Annexure A

Tripping of 400 kV Meramundali - JSPL Ckt 1& 2

Report on the grid event in Eastern Region (पूर्वी क्षेत्र में ग्रिड घटना पर रिपोर्ट)

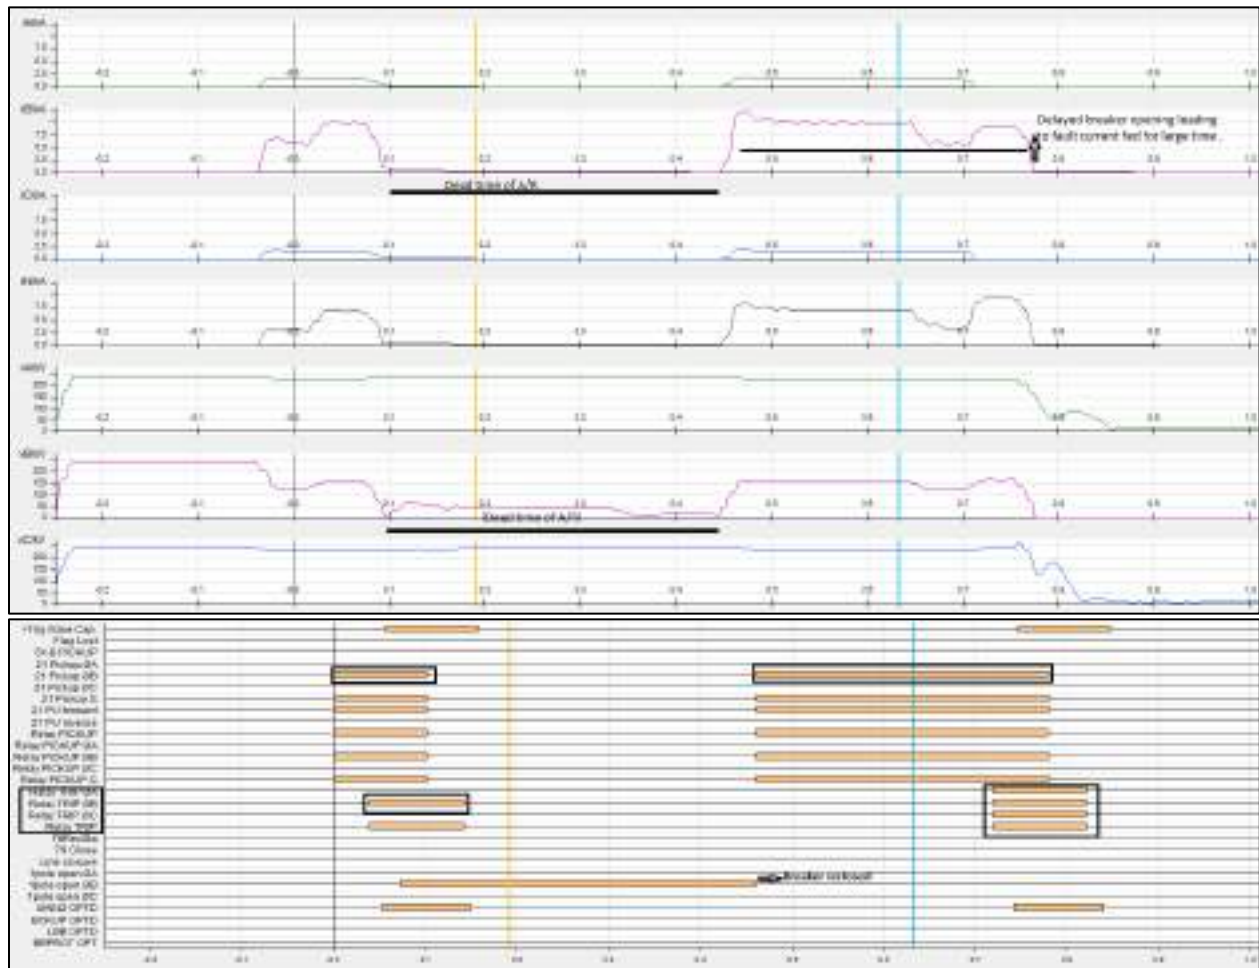
Low Dead time of Auto Reclose: There was Y-earth fault in the line at 35Km from meramundali , Y phase breaker got opened within 100 Ms but again after 350 ms Y phase breaker got closed and again it fed the fault for next 300 ms and then all 3 poles got opened.

From DR as well as PMU it appears that A/R dead time is kept only 350 ms as after 350 ms ,Y pole breaker got closed in both the cases of line tripping.

Reason may please be explained and **such low dead time is not recommended as it will cause secondary arcing** and in case of transient faults also ,chances of successful auto reclose is very low and also will cause unnecessary stress on breaker.

Annexure 5: DR output at Teesta III end for tripping of 400 kV Teesta III – Kishangunj S/C

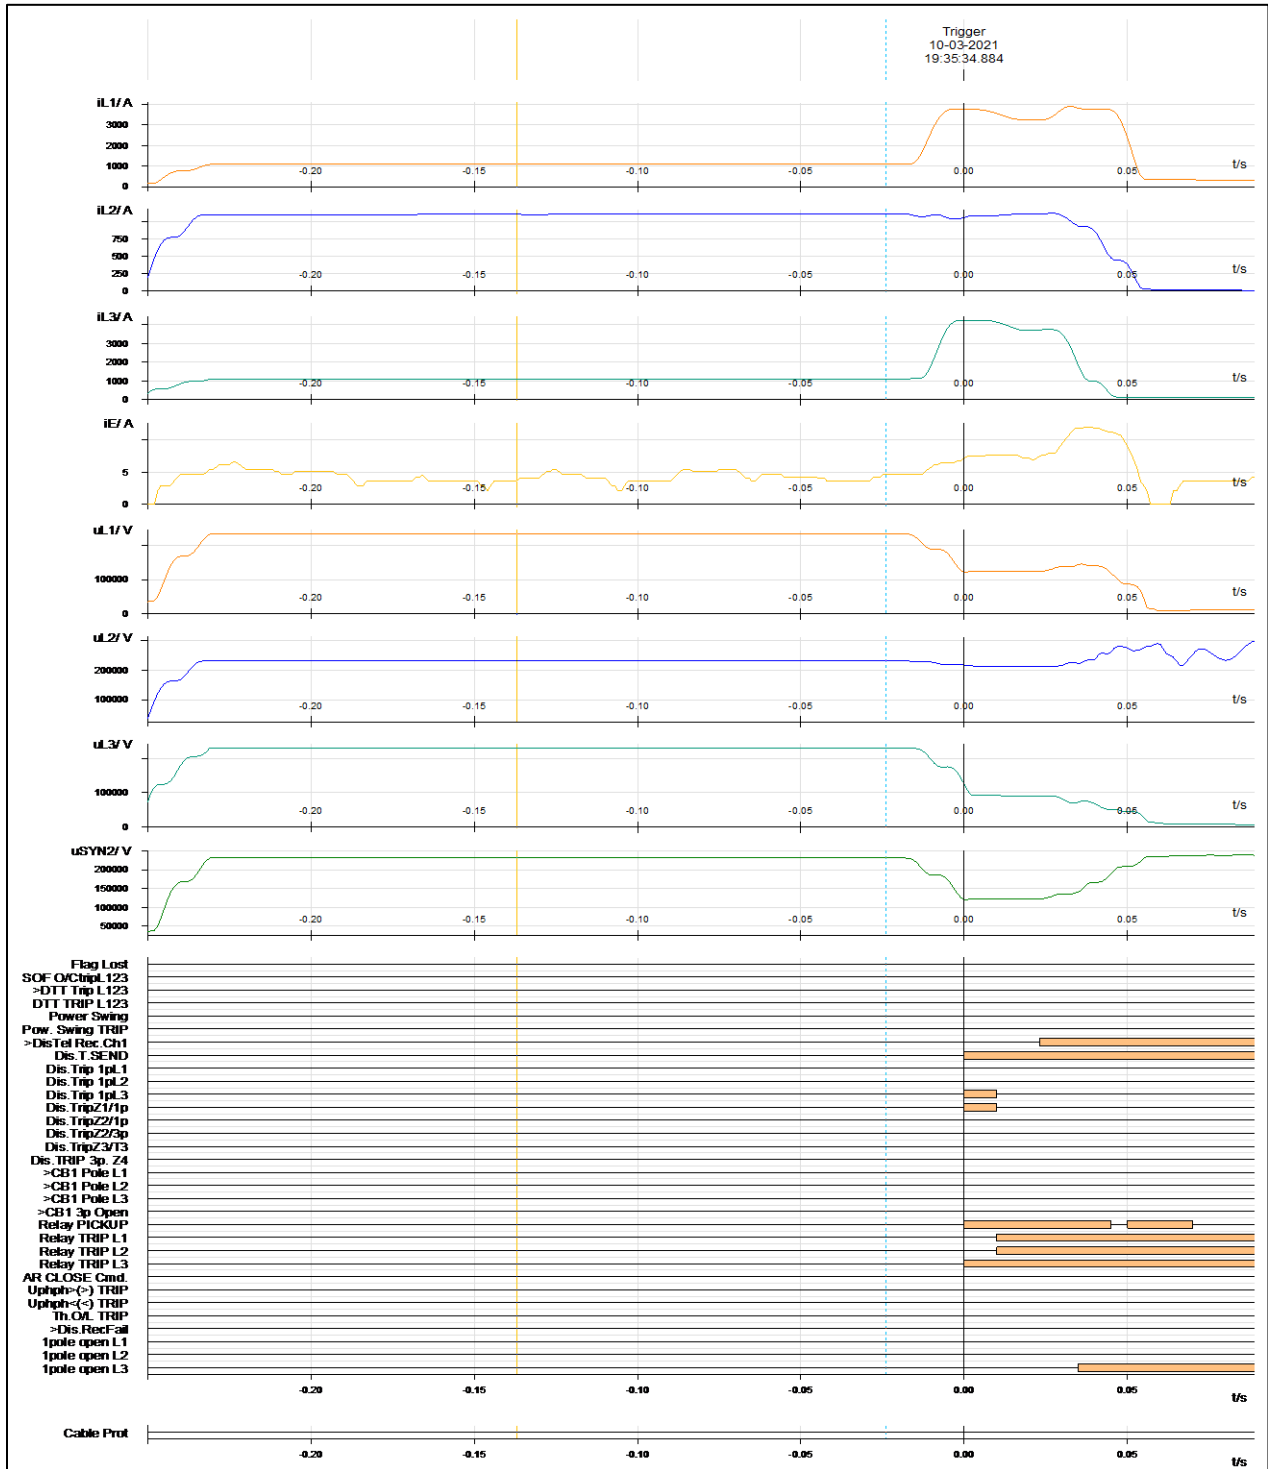
Time window is not properly configured.

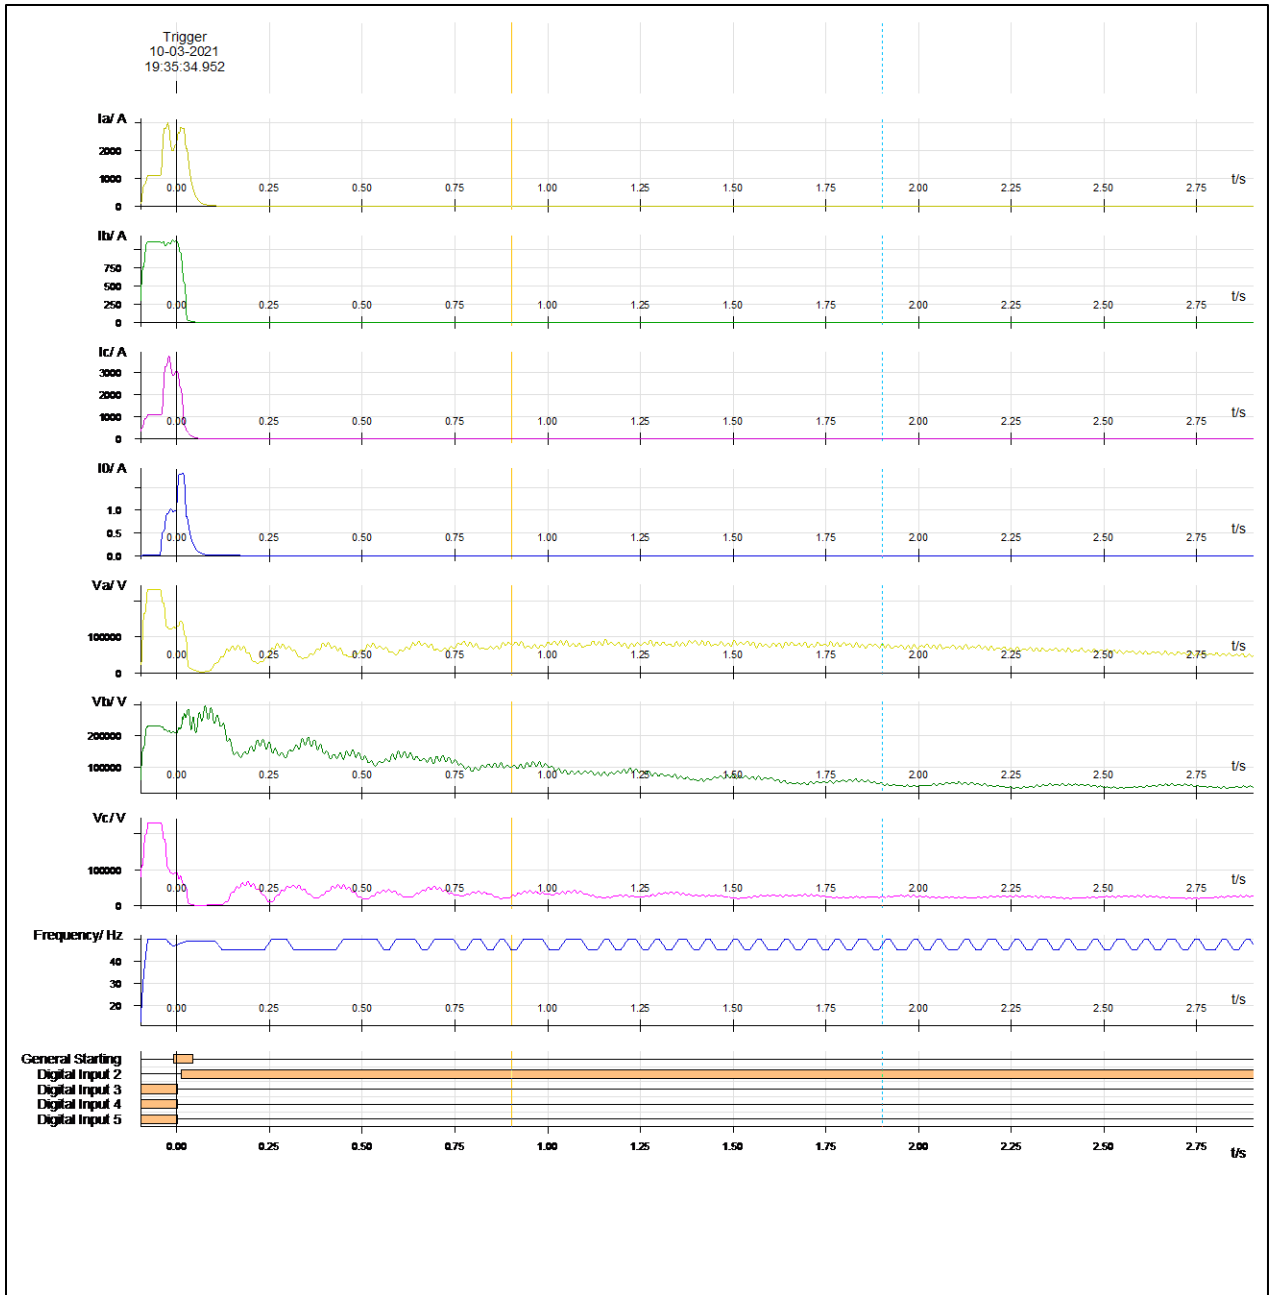
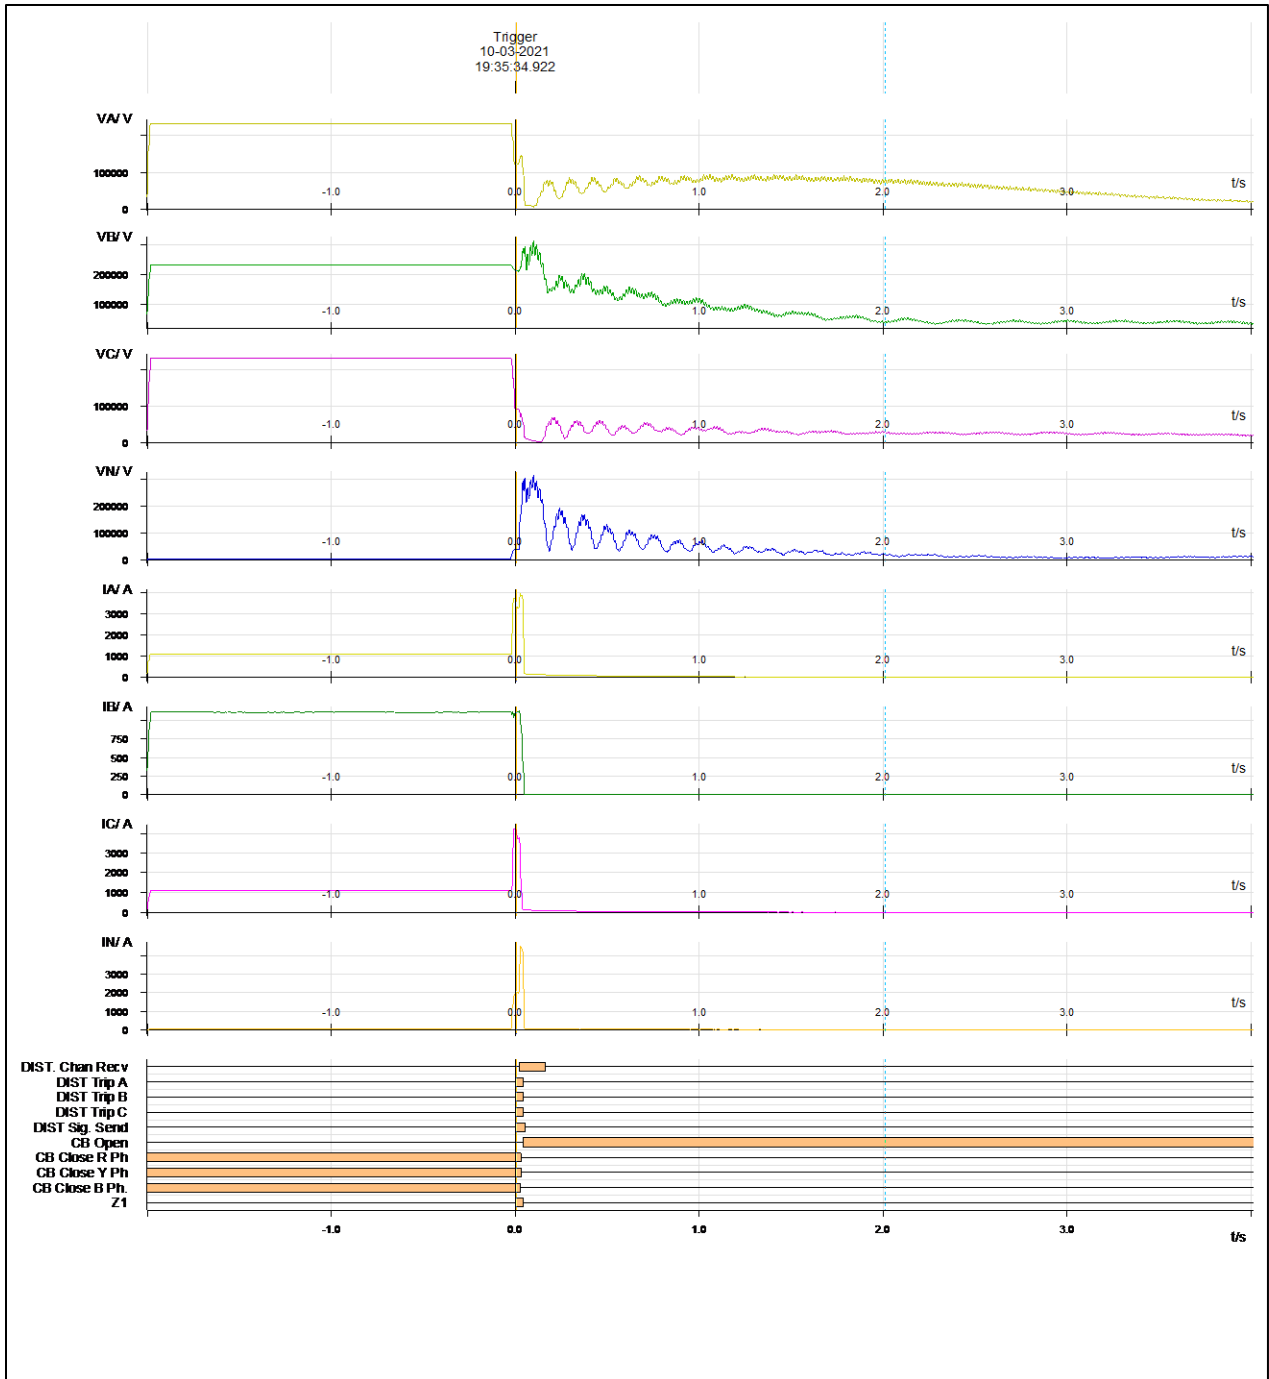
Digital channel is not configured as per ERPC's guidelines

Digital channel is not configured as per ERPC's guidelines

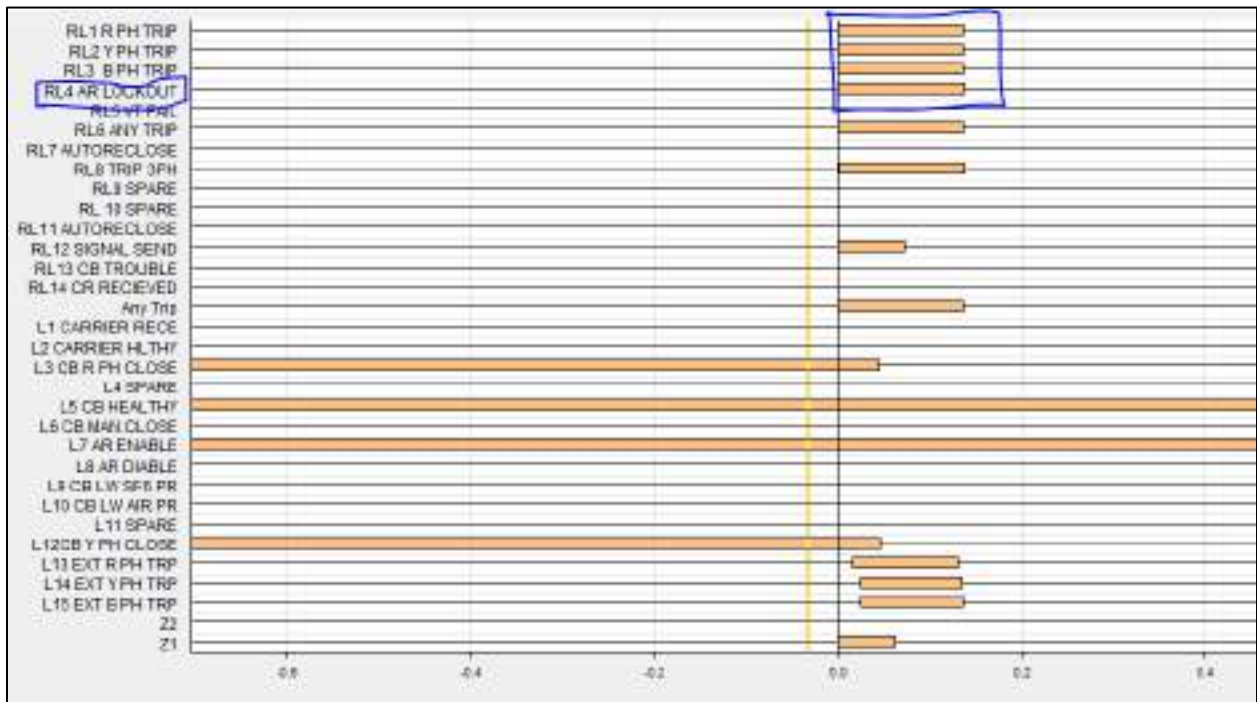
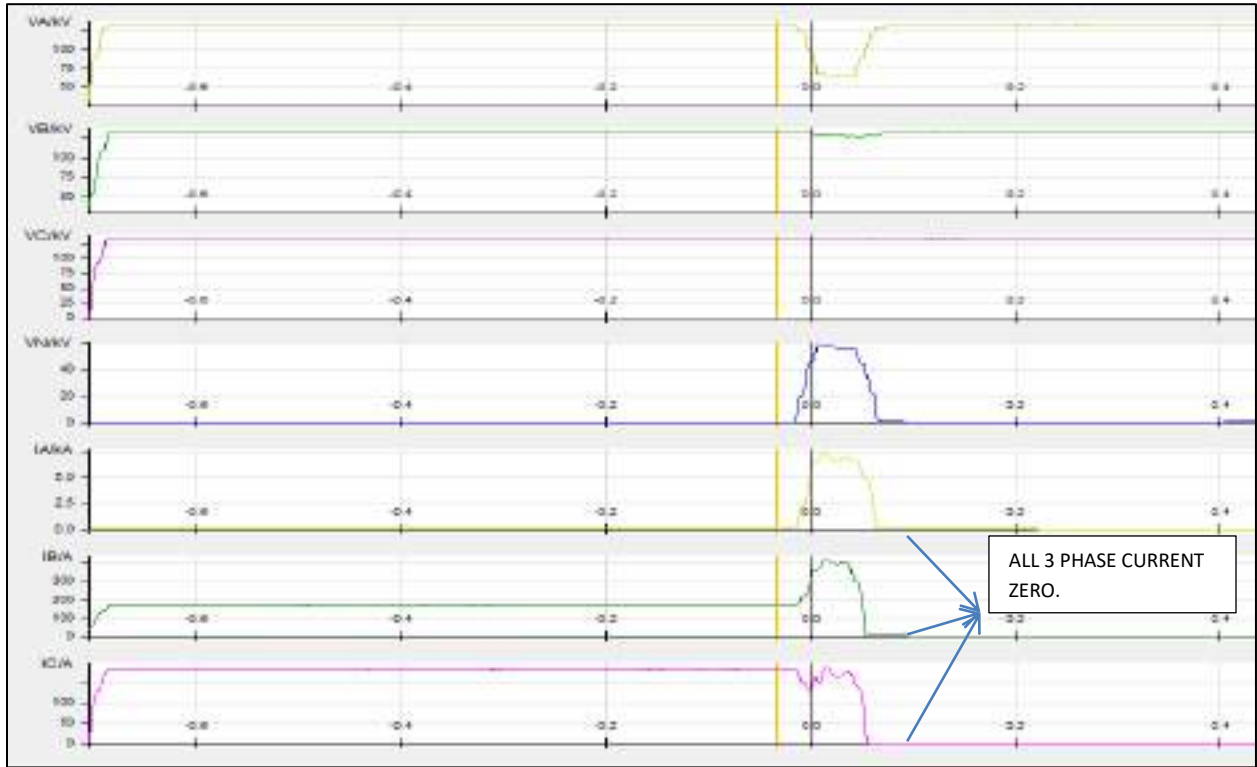
Protection related issue:**Non- Auto reclose at STPS END:**

In all cases of tripping it is observed that from Santaldih end, fault is in zone-1 and 3 phase tripping is occurring at the instant of single phase fault. So no auto reclose is observed in any event from Santaldih end ,if Auto reclose would have operated some tripping's of transient fault could have been avoided. Whether Auto reclose scheme is implemented and functional may please be communicated.

Carrier communication scheme failure : All faults were in zone-2 from Chandil end and delayed tripping observed after zone-2 time in each case, and all 3 phases from Chandil end tripped after z- 2time . Seems also carrier communication scheme not working as STPS end is sensing z-1 so it should send carrier signal to remote end to trip instantaneously faulty phase in case of zone-2 start at remote end and will further proceed for auto reclose after dead time .Delayed clearance also could have been avoided along with line tripping.

Healthiness of carrier communication scheme may also be checked and communicated.

RMS VALUE:

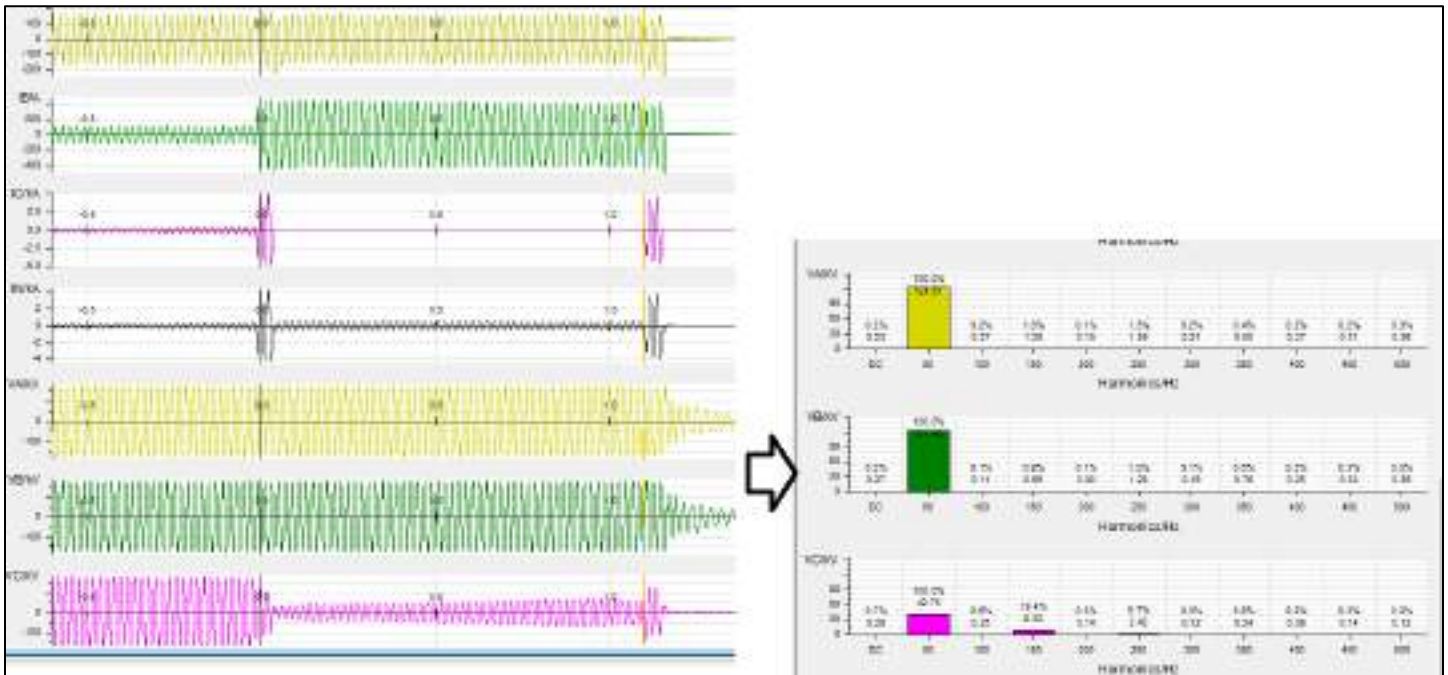
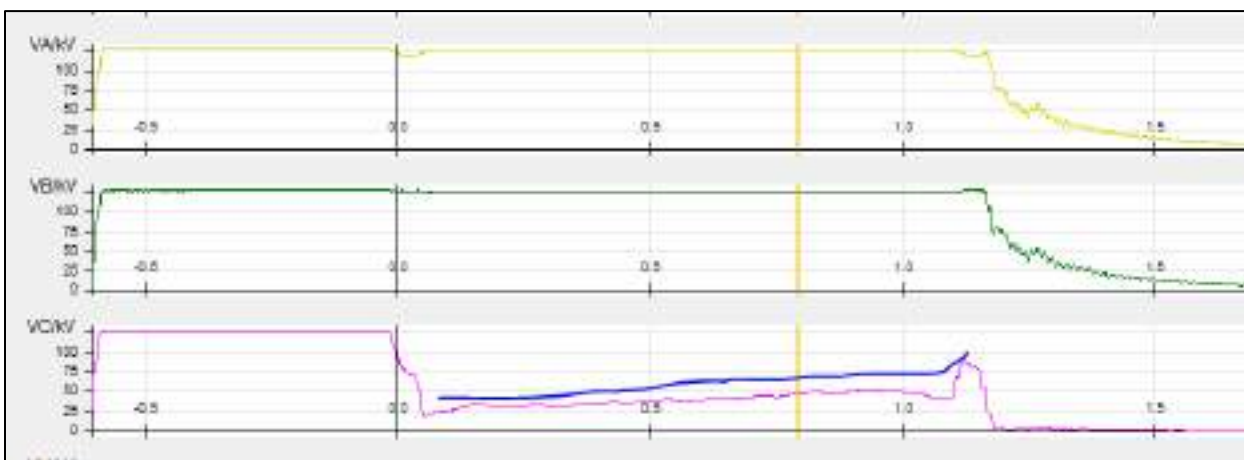
220 kv Daltonganj –Garwa –II tripped on 30 March with B phase to ground fault and during dead time of Auto reclose B, Phase voltage was existing with approx. 90Kv showing persistent arcing kind of phenomenon. Then at the charging instance after few milli-seconds line tripped due to Y-B fault and it appears from DR that prior to tripping B phase fault converted to Y-B fault which was pre-existing in the line with small magnitude which after charging increased in few ms and got detected by Distance protection and tripping issued .
